Solutions for P802.1Qbz / P802.11ak: Architecture issue

Norman Finn
January, 2013

Version 1

IEEE Std 802.11ad-2012 Figure 5-2

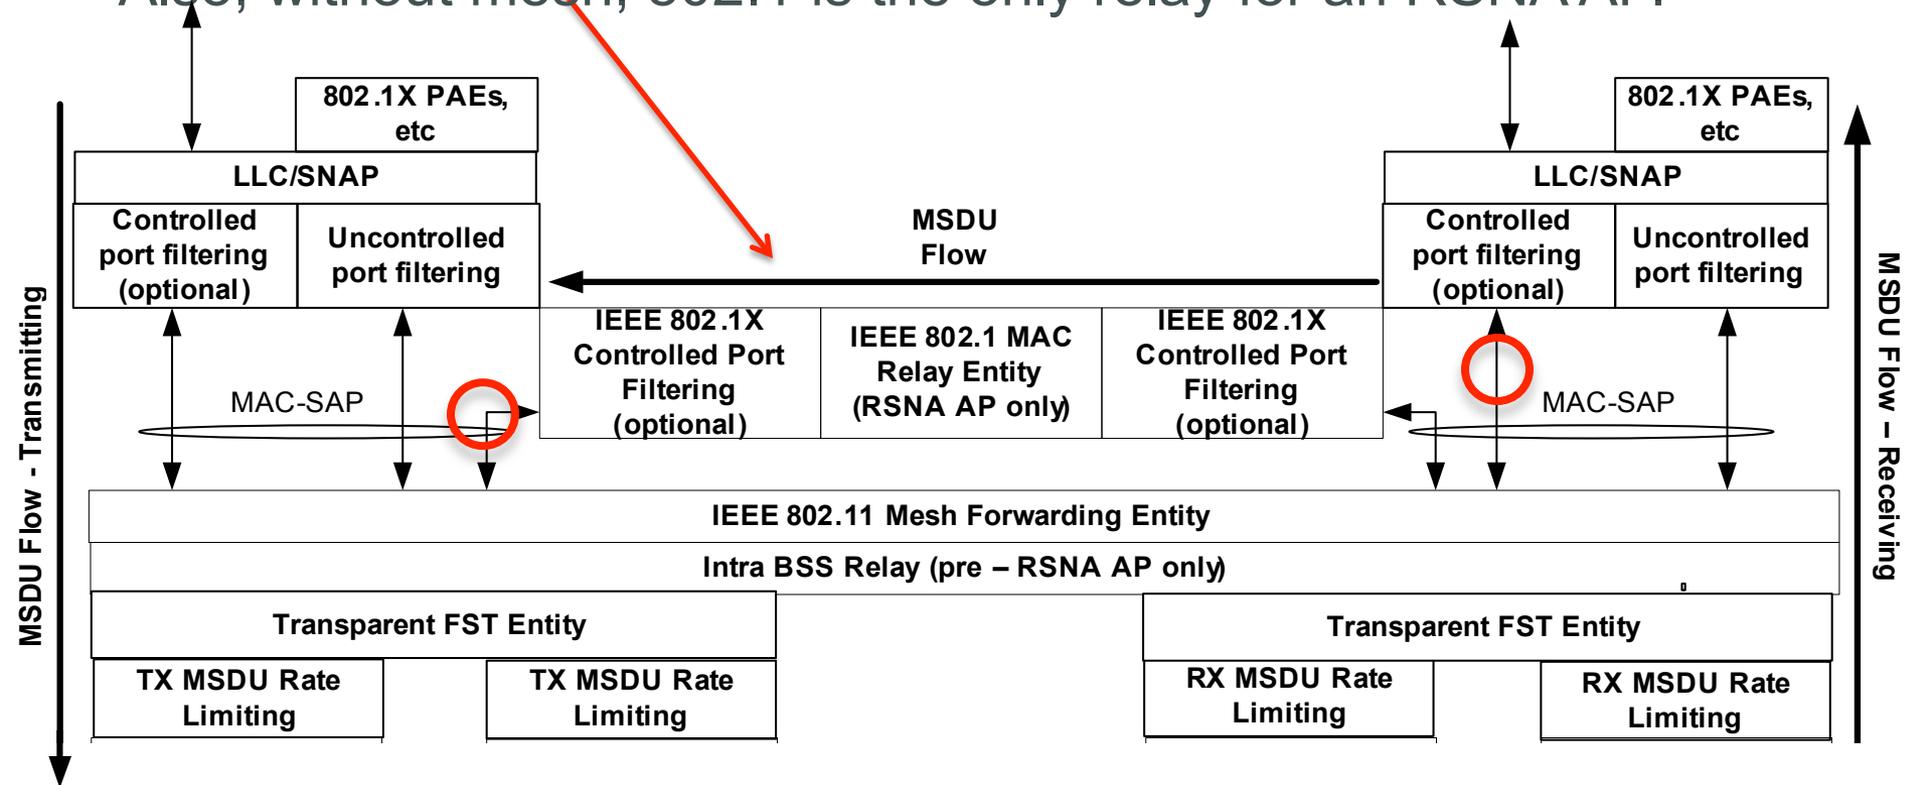
Is .11ad Fig 5-2 a “baggy pants”? Or not?

- This arrow shows a flow from AP through 802.1 relay back to AP. An 802.1 relay cannot do this unless it sees different stations as different ports. Arrow makes no sense if this is not baggy pants.
- Also, without mesh, 802.1 is the only relay for an RSNA AP.

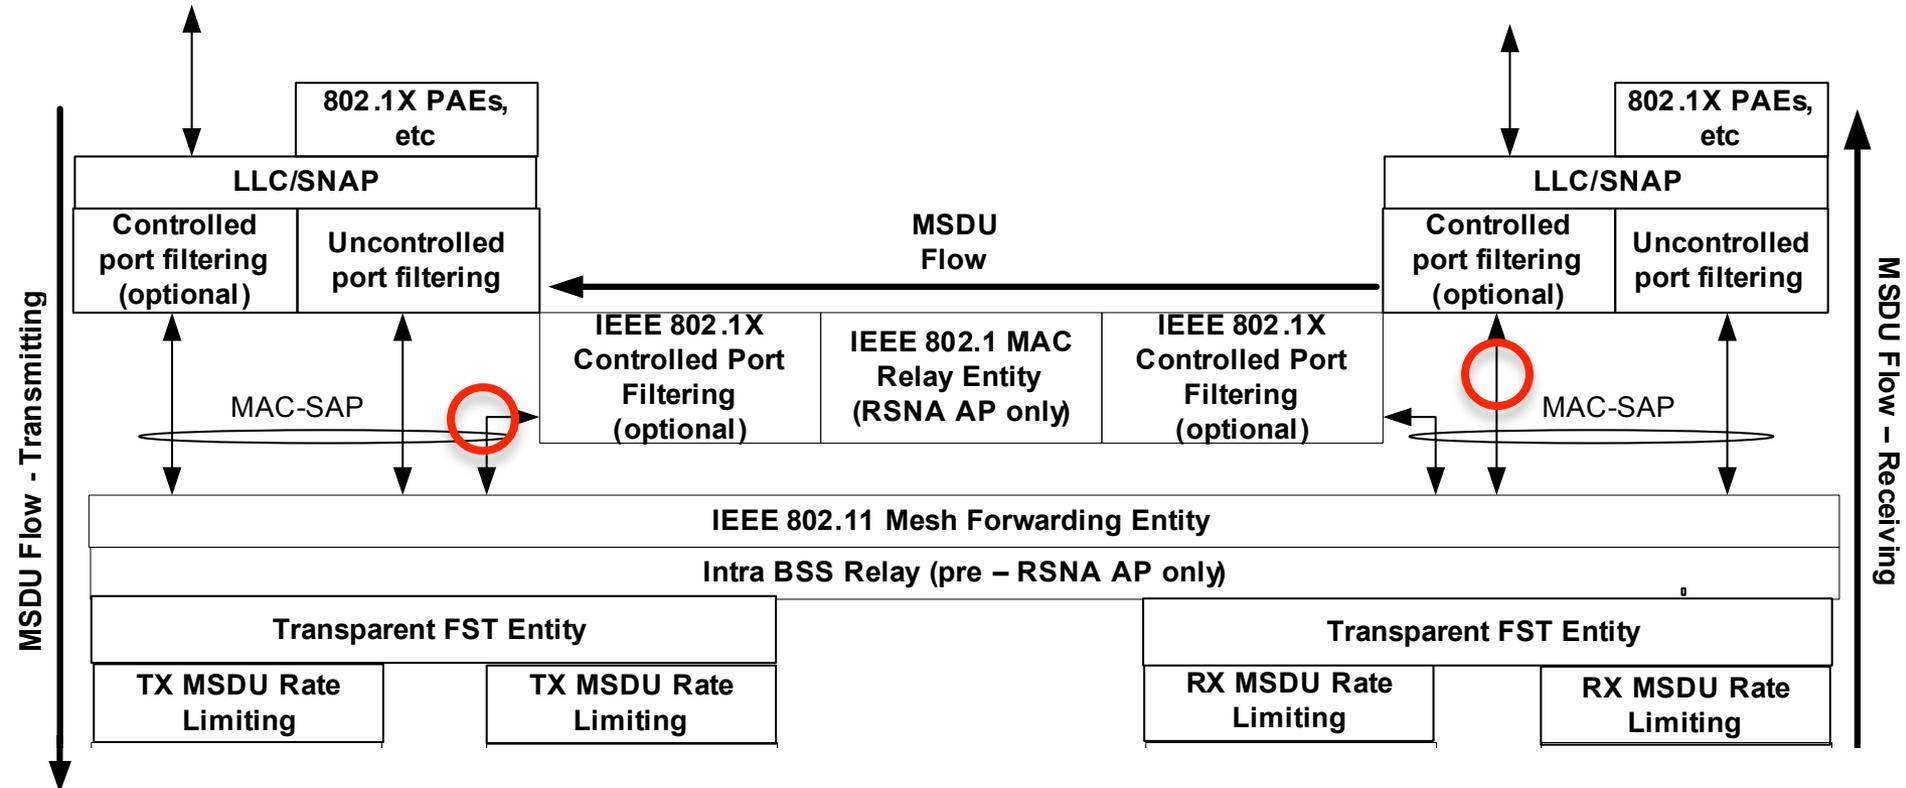
- The FST (Fast Session Transfer) diagram clarifies this. The empty box in 5-1 is three entities all accessing the MAC-SAP.
- The double-ended arrows seem to be a little **confused**, given the one-way port representation, but the meaning seems clear.
